Page 1. This is the first of 4 pages illustrating the wiring changes to take an existing SPA-400 installation and rewire it for a SCI-S4 intercom. The illustration below is of the original SPA-400 installation.

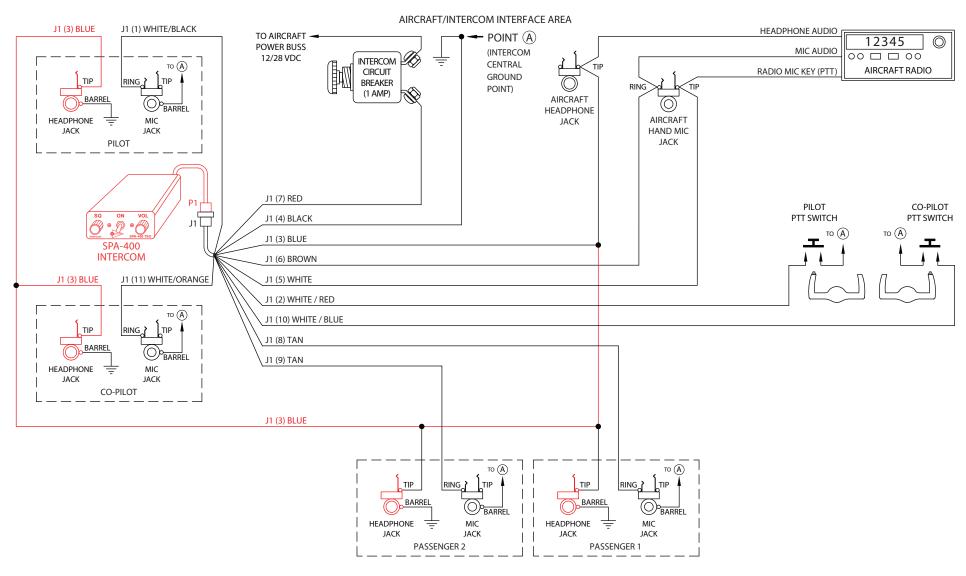
Page 2. Disconnect the tip terminal of the pilots headphone jack from the blue wire. Make sure that the **J1 (3) Blue** wire is still connected to the tip of the radio headphone line. Disconnect and remove the pilot, co-pilot and passenger headphone jacks.

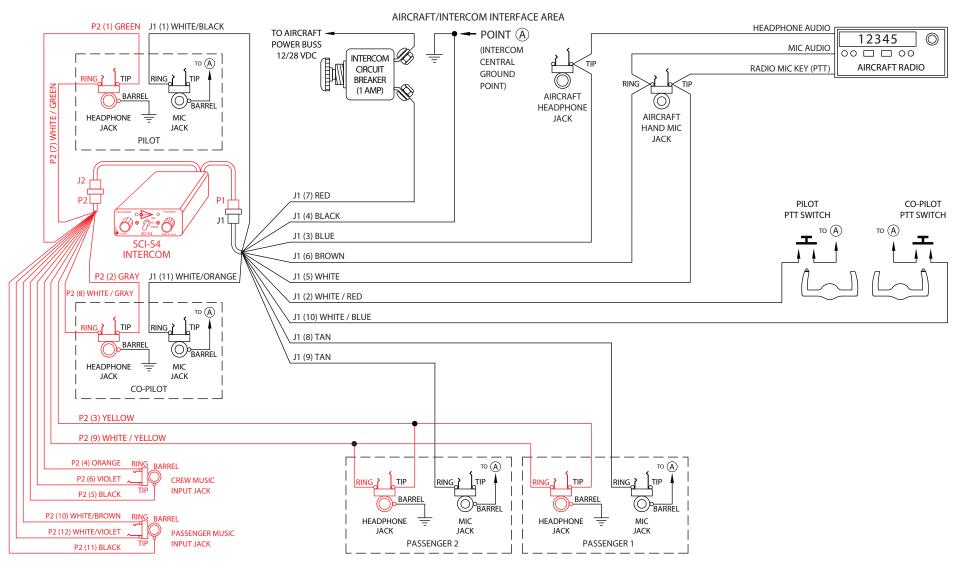
Page 3. Install the supplied stereo headphone jacks and connect to their respective pins on the headphone / intercom interface harness **P2**. Install the crew and passenger music input jacks and connect to the interface harness. The customer supplied music sources are connected at these jacks.

The SCI-S4 intercom is connected to the new interface harness **P2** and the existing harness **J1** of the original SPA-400 installation.
